Woodville Corridor Planning Framework

| Project Name | Woodville Road Corridor - acoustic / air quality | | |
| Subject | Woodville Corridor Planning Framework – Acoustic and air quality study addendum report | | |

Figure 1 Woodville Road Corridor Key Plan

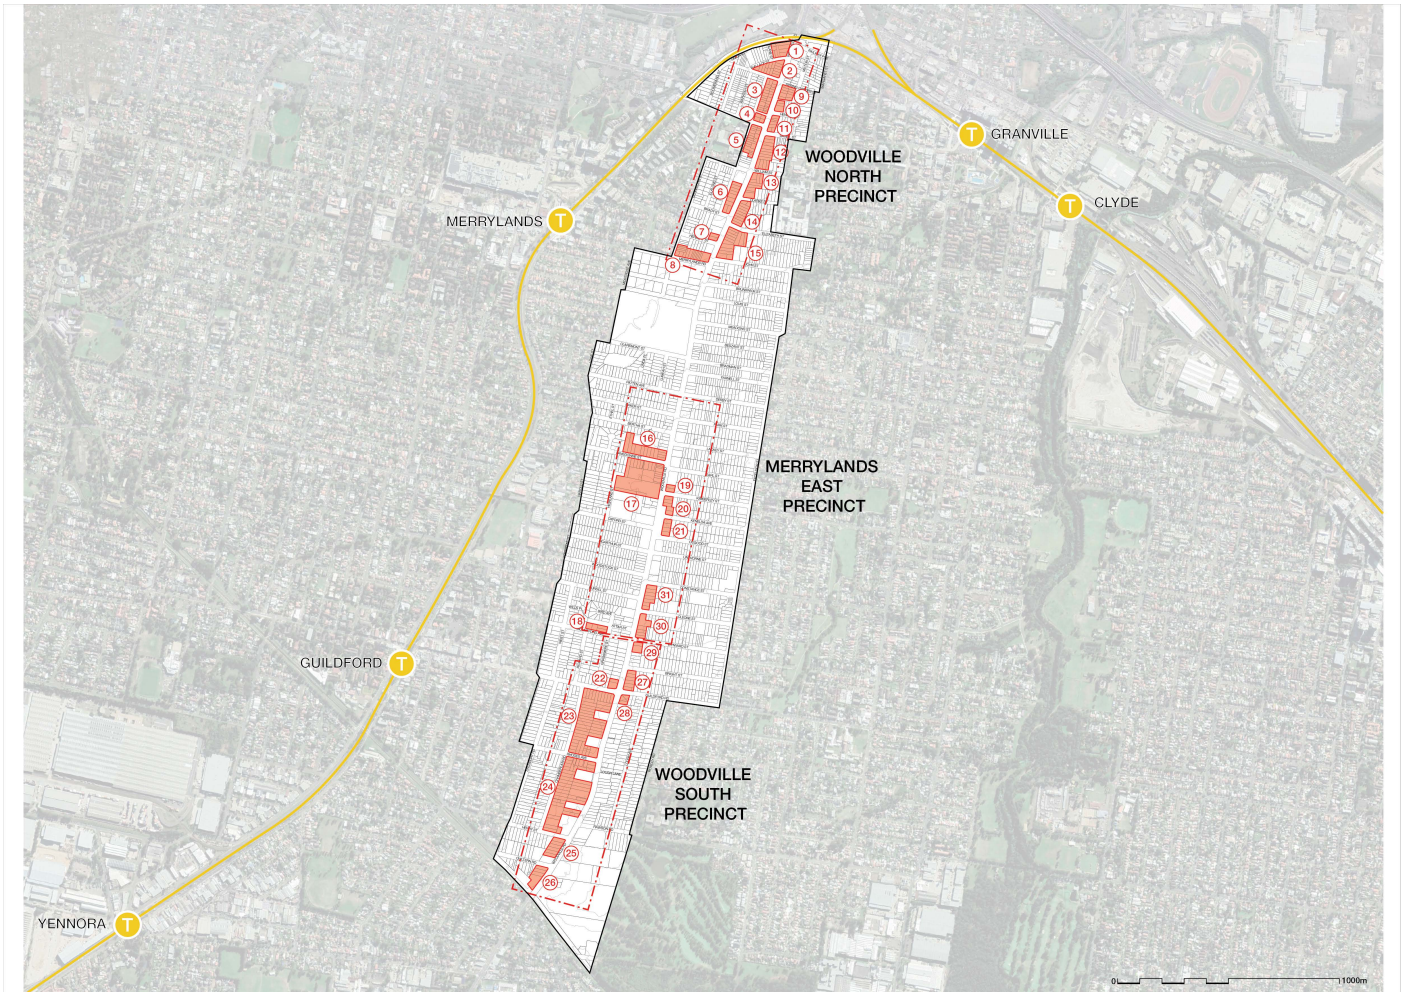
Two additional sites are proposed in the Merrylands East Precinct, these have been labelled Site 30 and Site 31 in the Amended Urban Design Report and are shown on Figure 1. Both sites front Woodville Road and occupy the width between two side streets; Wynyard Street, Cleone Street and Constance Street.

A review of the acoustic and air quality report determined that Site 19 and Site 20 in the Merrylands East Precinct have similar design features (setback, land zoning, FSR and building height) to the new proposed sites and as such, the modelling of air and noise would be applicable to the two additional sites. The location of these sites and the additional sites is shown on Figure 2.

The architectural design categories determined for Site 19 and Site 20 and other similar sites are provided in Appendix D of the Acoustic and air quality study report (GHD, 2023). The results for Site 19 and Site 20 can be considered representative for Site 30 and Site 31 and the recommendations for the DCP planning controls are still considered appropriate.

Figure 3 Site 15 3D form (left: original, 2023; right: amended, 2024)

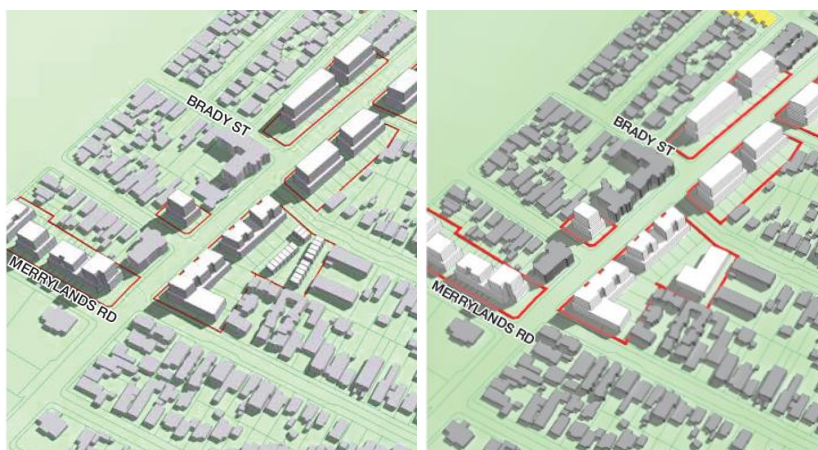
Following a Council resolution in March 2024, the portion of Site 15 not fronting Woodville Road was changed to R4 High density residential, this includes a 12m HOB limit and 0.8:1 FSR. The change in the proposed building envelope is shown on Figure 3 and it can be seen that the amended footprint is not proposed to be significantly further from Woodville Road or higher than buildings fronting Woodville Road and providing shielding. As such the air and noise modelling results for Site 15 remain valid and the recommendations for the DCP planning controls are still considered appropriate.
